~~GREENSMART TO DO LIST~~ DONE

HOT FLASH # 2912

Improve Pilot Assembly:

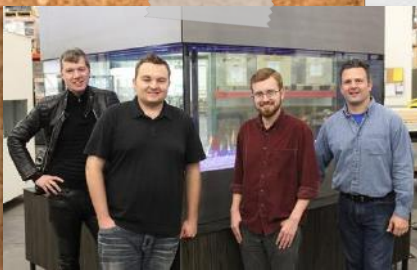
✓ Switch to PSE Pilot

✓ Upgrading to shepherd's
hook flame sensor

✓ Sheath sensor wire
